**City of Bellevue
Development Services Department
Land Use Staff Report**

Proposal Name: ACST (Pine Forest) Master Development Plan Amendment

File Number: 23-101054-LP – ACST MDP Amendment

Decisions Included: Master Development Plan Amendment and SEPA Determination

MDP LANDSCAPE PLAN

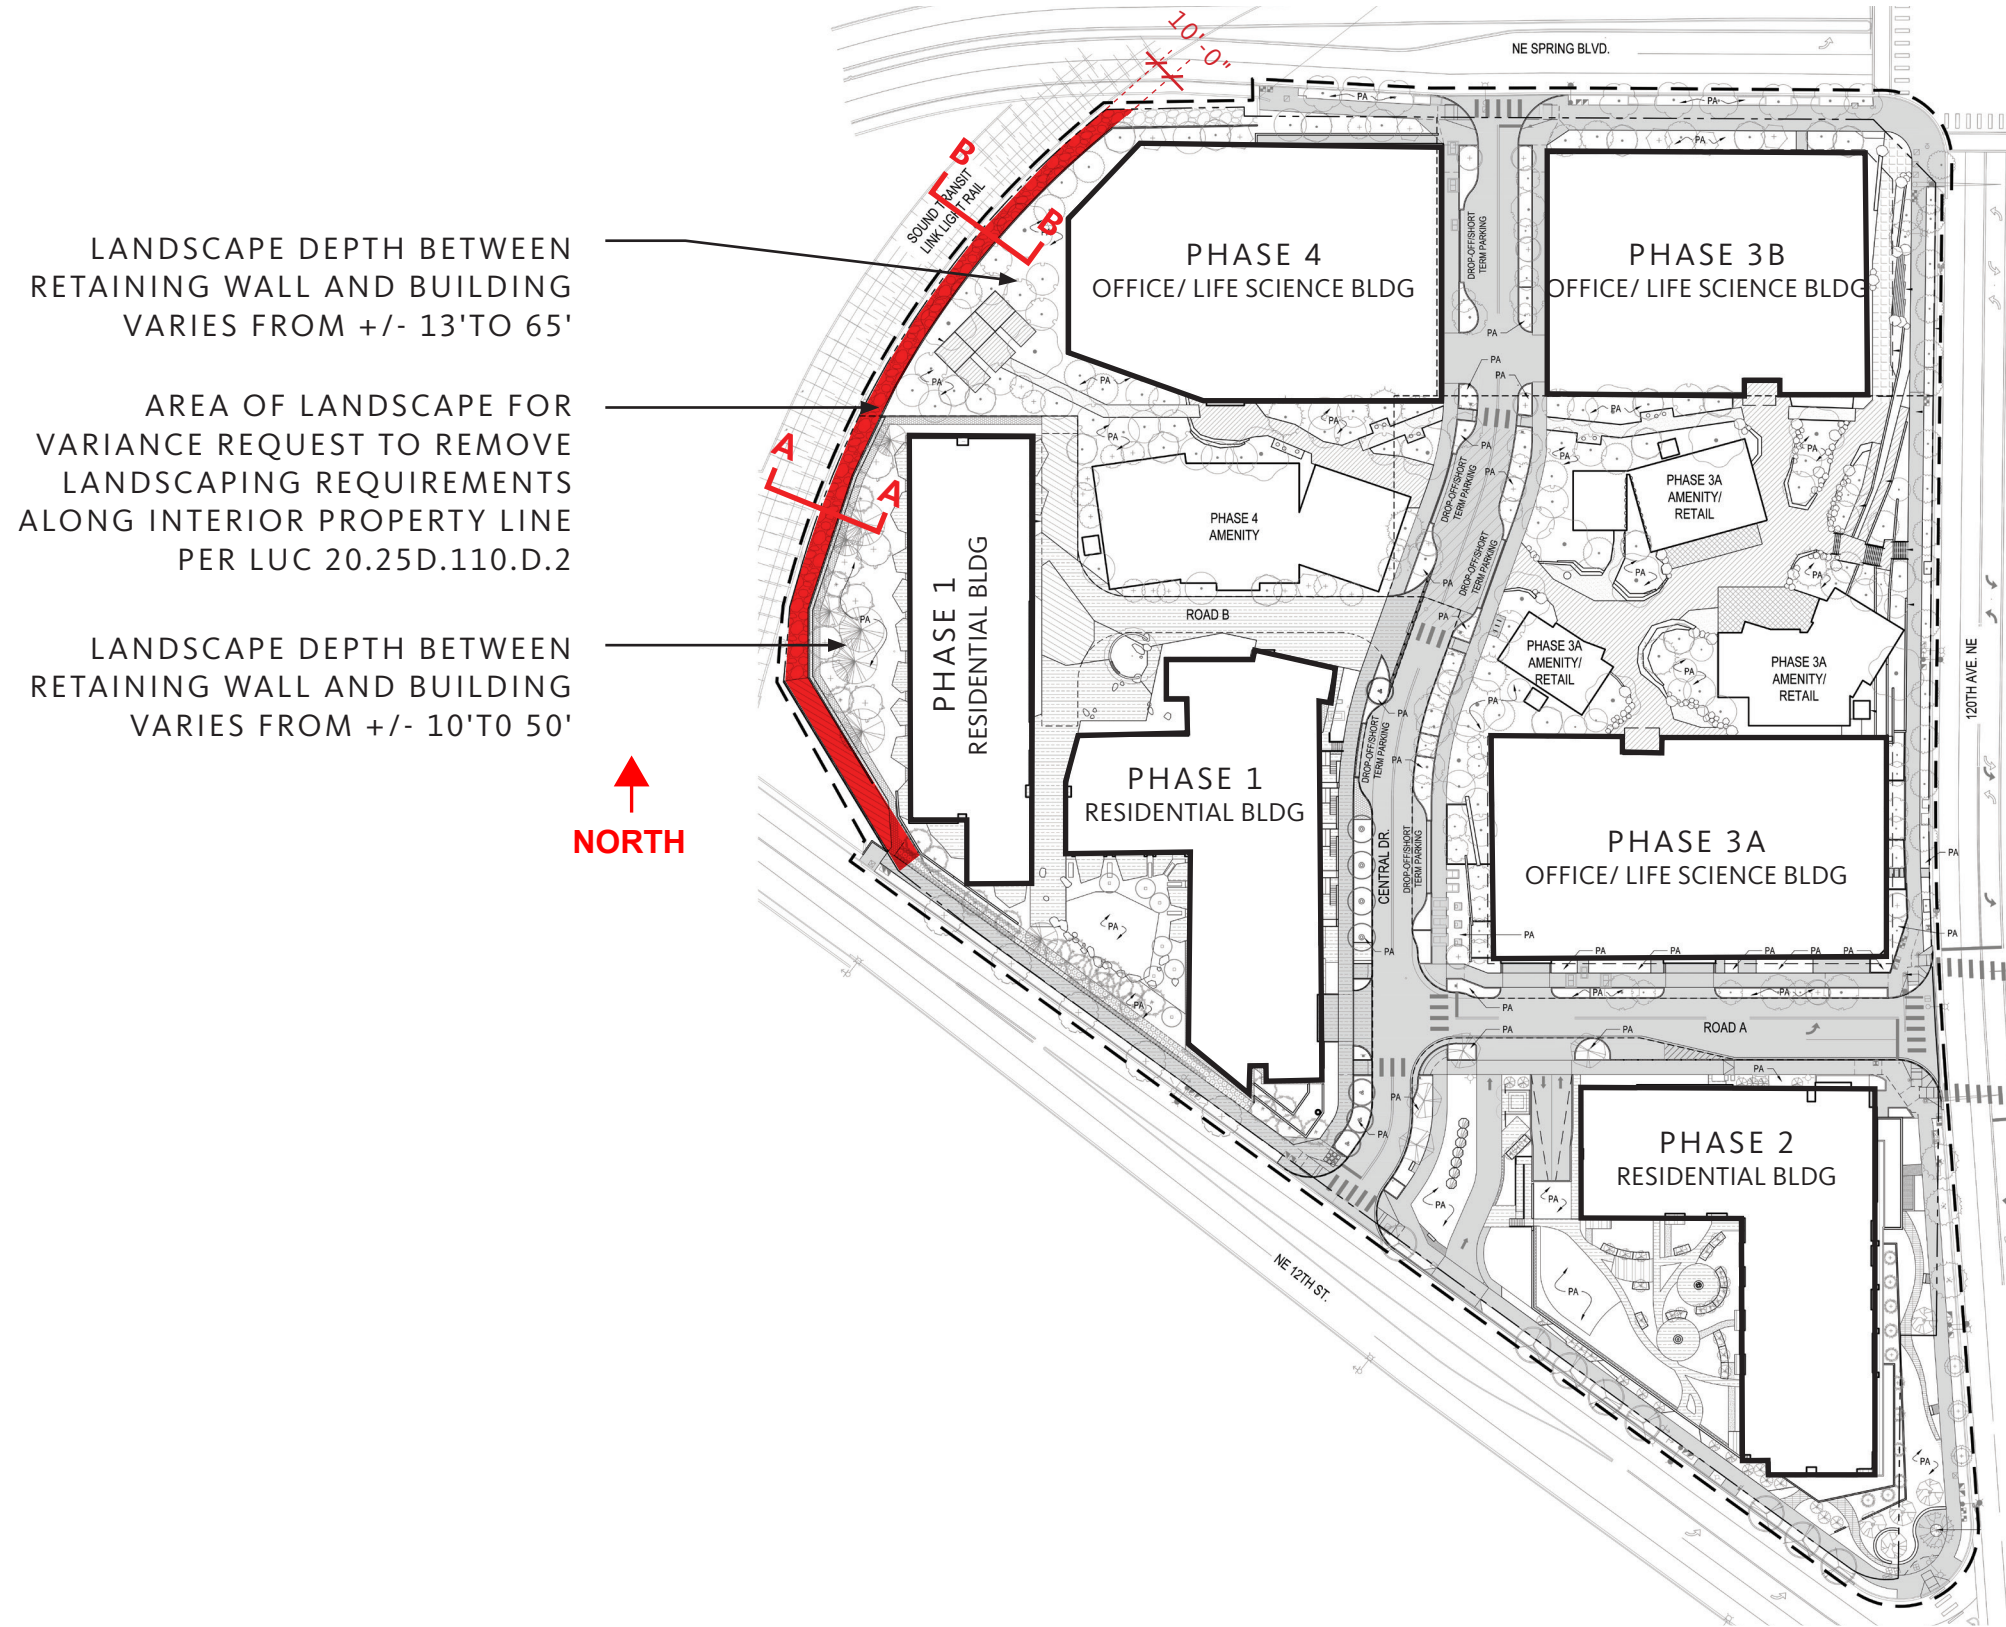
- If you plan to remove all of the required 10' interior property line landscaping along the western property line to accommodate the required Transportation/ROW pathway, this will require a Variance (LS) application, which should be submitted and reviewed as part of this MDP amendment. Due to the unique circumstances of the site and need for the pathway, a Variance application could be supported.
- [Land Use Code Variance | City of Bellevue \(bellevuewa.gov\)](https://www.bellevuewa.gov/land-use-code-variance)

While the applicant has requested to deviate from the required 10' landscape buffer adjacent to the western property boundary, not all landscaping is eliminated for the entirety of the development along this western (interior) property boundary. Both Phases 1 and 4 anticipate installing landscaping along the western sides of each development to still provide a landscape buffer adjacent to each building structure to help buffer building elevations, meeting the intent of the code. See section drawings above. Refer to Section IX below for responses to Variance decision criteria.

SECTION A-A AT PHASE 1

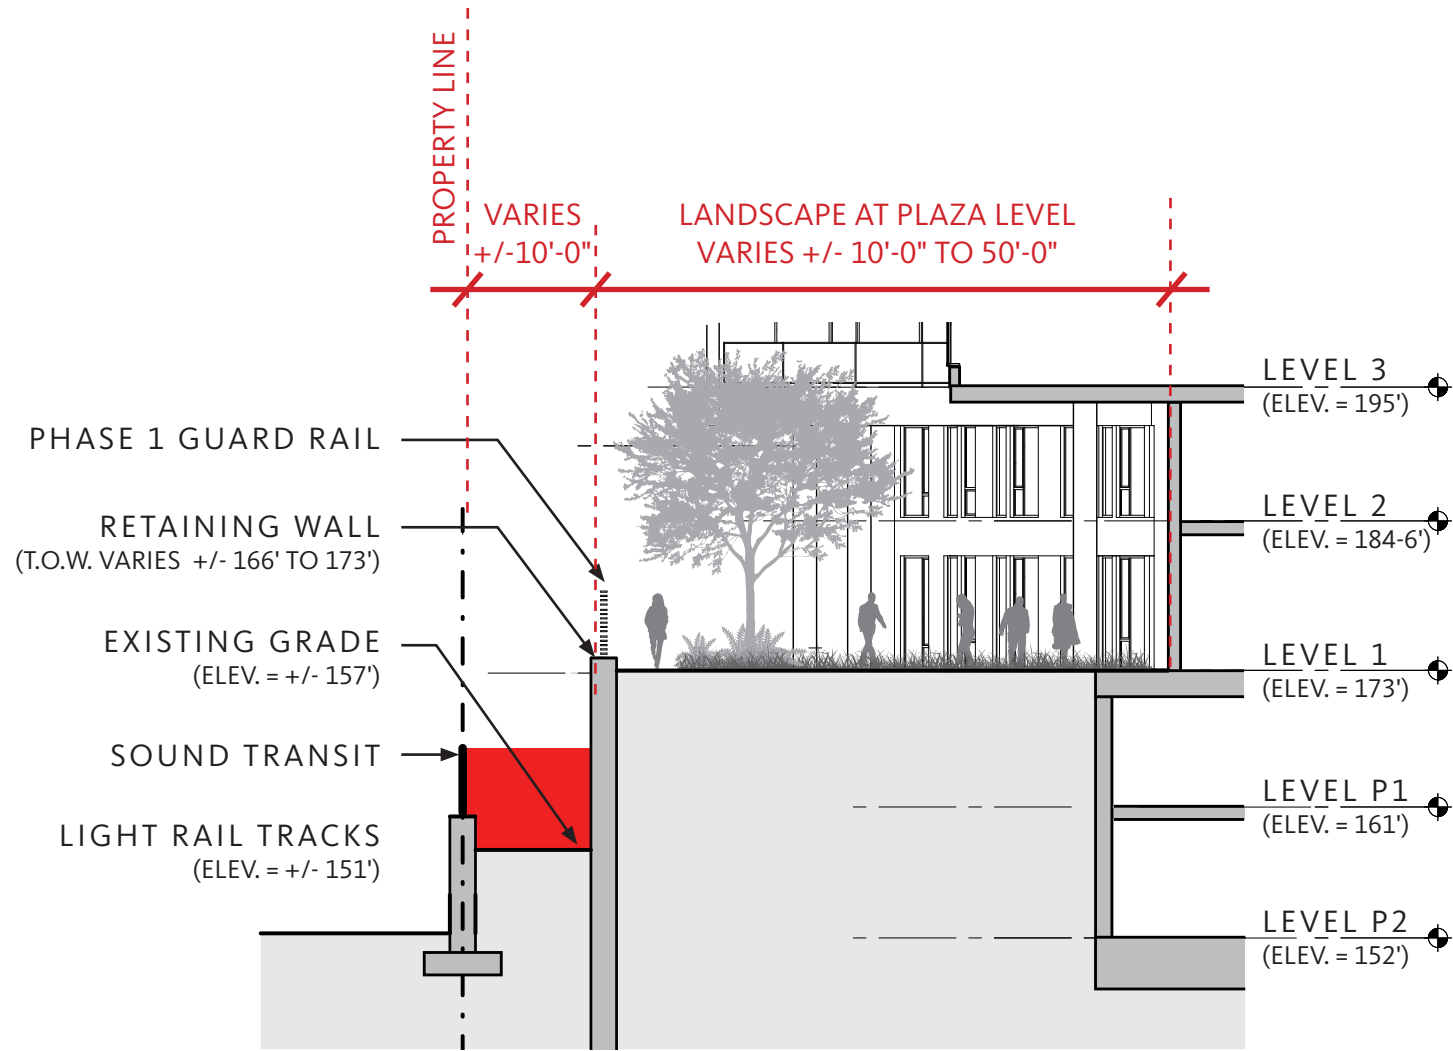
- boundary, resulting in an un-useable space between the proposed retaining walls and the western property boundary. See section drawings below.
- Although there will be 5'-10' of space between the fenced property boundary with Sound Transit and the proposed terraced retaining walls, this space will be undesirable for plantings meeting the required Landscape Buffer requirements of 20.25D.110.D. Significant plantings are not anticipated to thrive in between retaining walls due to shading from existing and proposed conditions. It is preferred to keep this area clear in case of any maintenance needs and to deter public safety issues from occurring. This is also an area that will not be visually prominent from public rights of way due to these surrounding conditions. Installation of landscaping would not provide any buffering from building elevations.
